MASTER PLAN AND ZONING COMMITTEE
City of Novi Planning Commission
August 25, 2021 at 6:00 p.m.
Novi Civic Center – Council Conference Room
45175 W. Ten Mile, Novi, MI 48375
(248) 347-0475
AGENDA

A. Rezoning request by MI CAT to rezone from I-1 (Light Industrial) to I-2 (General Industrial) with a Planned Rezoning Overlay (PRO)

TO: MASTER PLAN AND ZONING COMMITTEE
FROM: CHRISTIAN CARROLL, PLANNER
THRU: BARBARA MCBETH, AICP, CITY PLANNER
SUBJECT: CONSIDERATION OF REZONING REQUEST FOR
JZ21-22 MI CAT CATHERINE ACCESS DRIVE
DATE: AUGUST 19, 2021

Rezoning Request from I-1 (Light Industrial) to I-2 (General Industrial) with Planned Rezoning Overlay (PRO)

OVERALL SITE PLAN

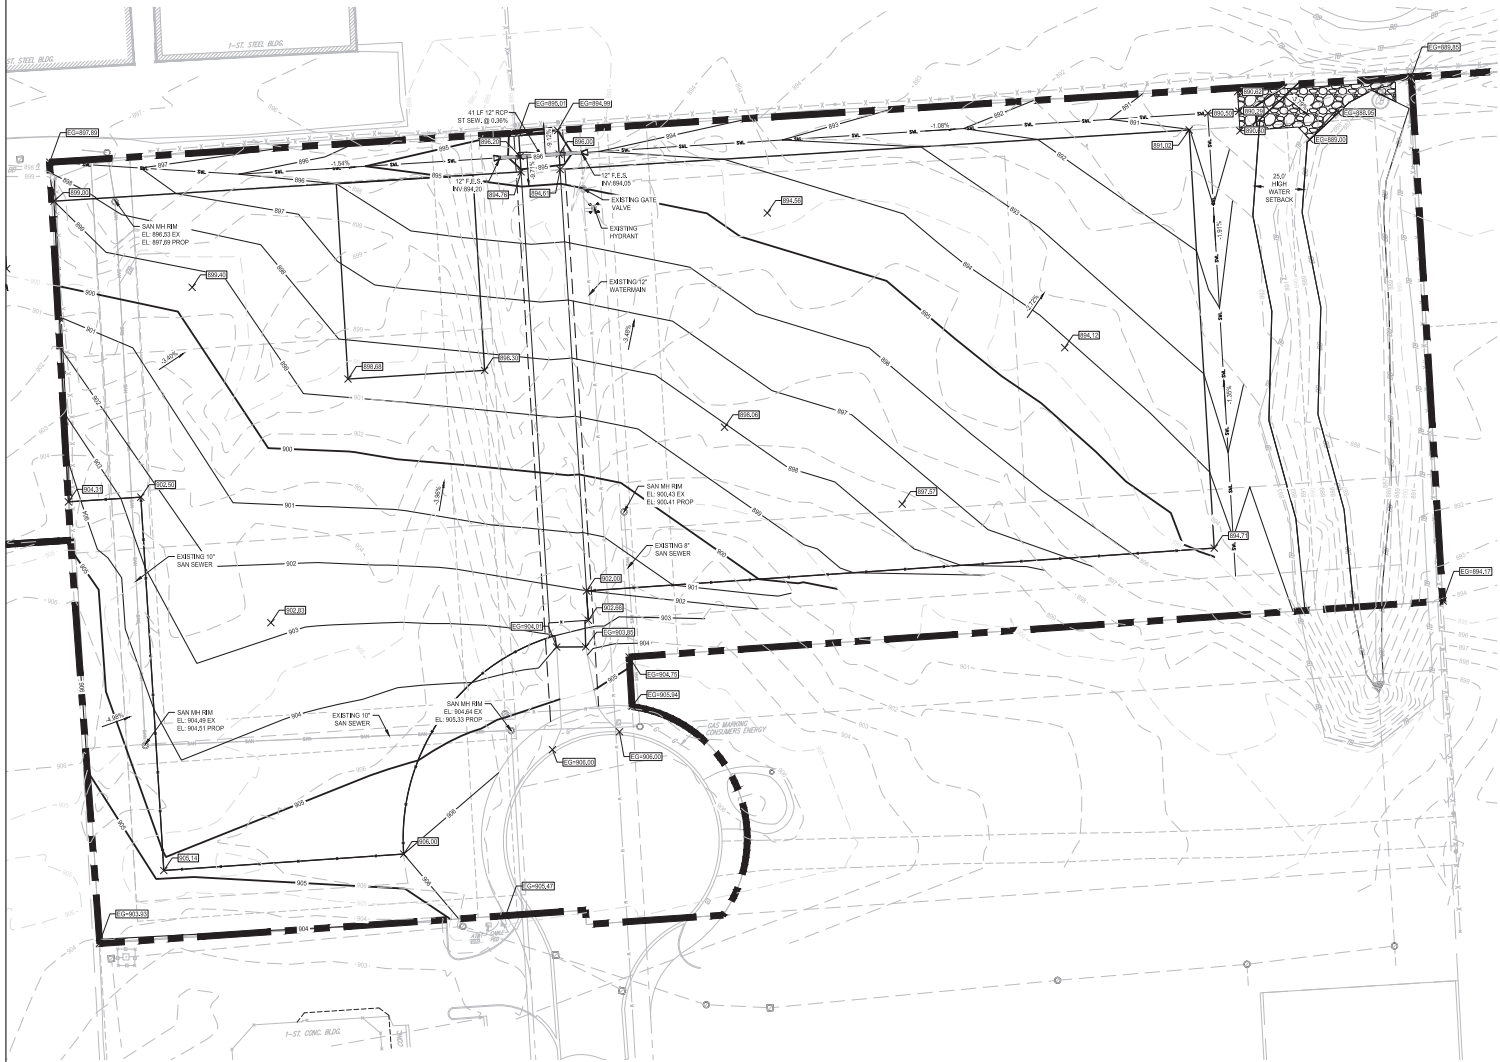
3. Note 8 on Sheet C101 has been updated to indicate required compliance with City of Novi requirements.
 4. Sheet C101 has been updated to provided better clarify between existing conditions and proposed improvements.

7. Sheet C110 has been updated to reflect existing and proposed sanitary sewer rim information.
 8. The intent is for the existing hydrant to remain. The C101 drawing has been updated to note the requirement of proposed bollards around the hydrant.

SITE LANDSCAPE PLAN

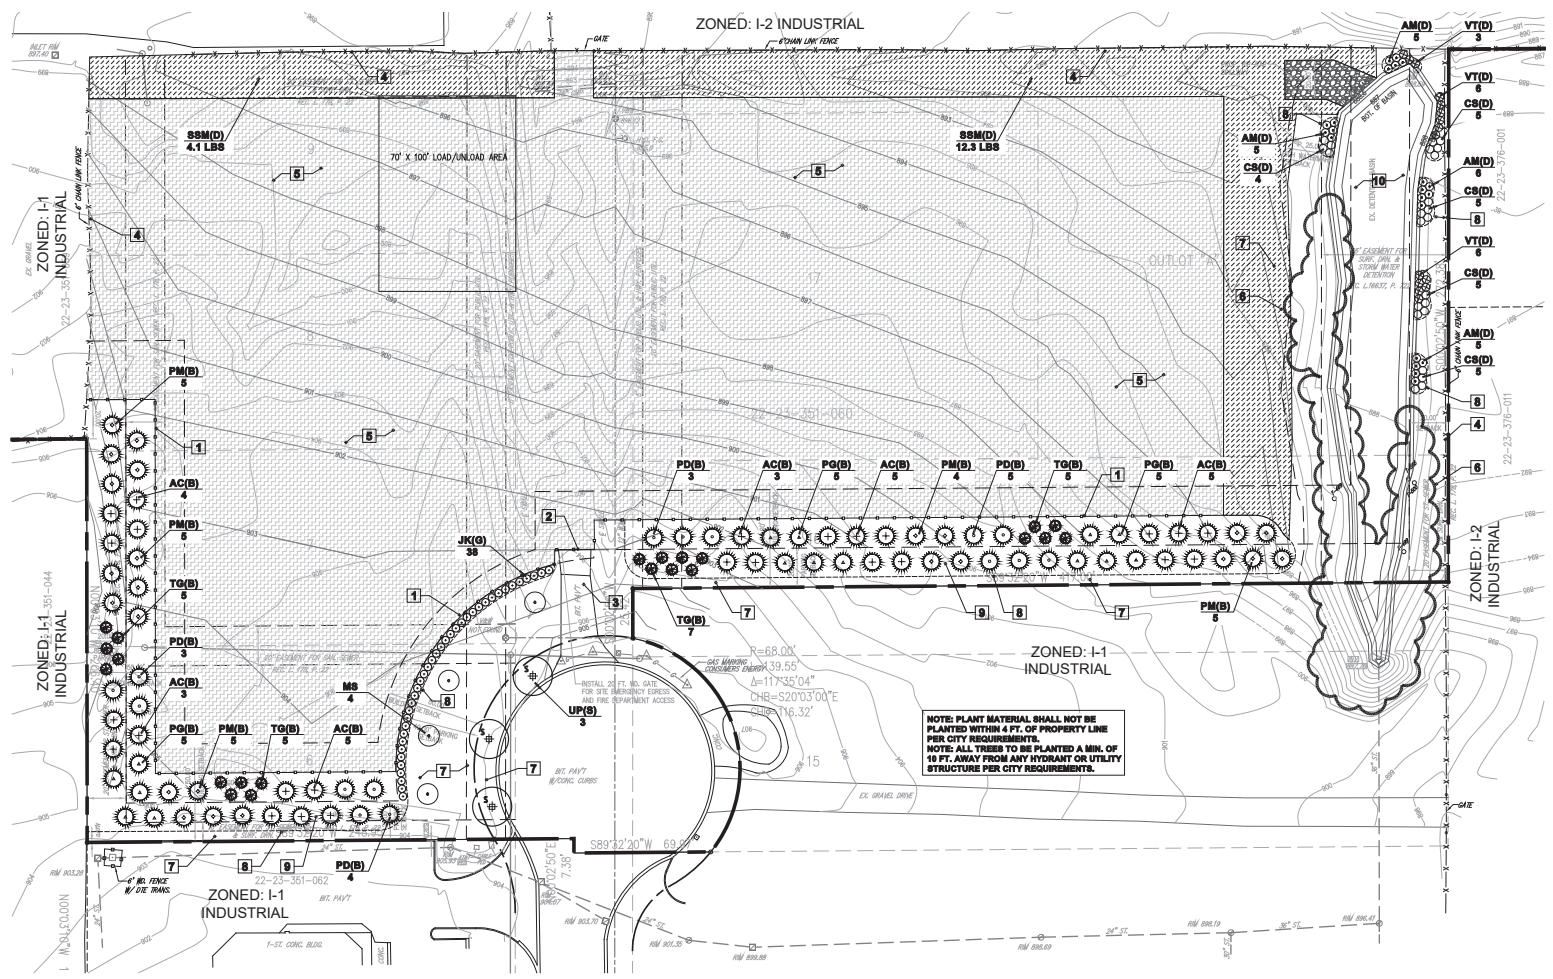
2. Berm adjacent to ROW (Sec. 5.5.B, LDM 1.b): A berm is required along the public right-of-way. Instead, an evergreen shrub "wall" has been provided by the applicant, which is **supported by staff if a few ornamentals are added because it meets the intent of the ordinance.**

3. Tree Diversity (LDM, Section 4): The proposing landscaping of the site does not meet the Tree Diversity requirements of the Landscape Design Manual. **However, staff supports this deviation because the primary importance for the landscaping is the screening of the storage yard and there are limited evergreen options available, especially those native to Michigan. Please consider using more large evergreen species, such as Green Giant Arborvitae, or other large evergreen species in place of the Picea Glauca to diversify the screening plantings in case a disease or pest decimates on of the species used (i.e., Needle cast causes significant issues for the Colorado Blue Spruce within the City of Novi, so you may want to use something other than a Colorado Blue Spruce).**
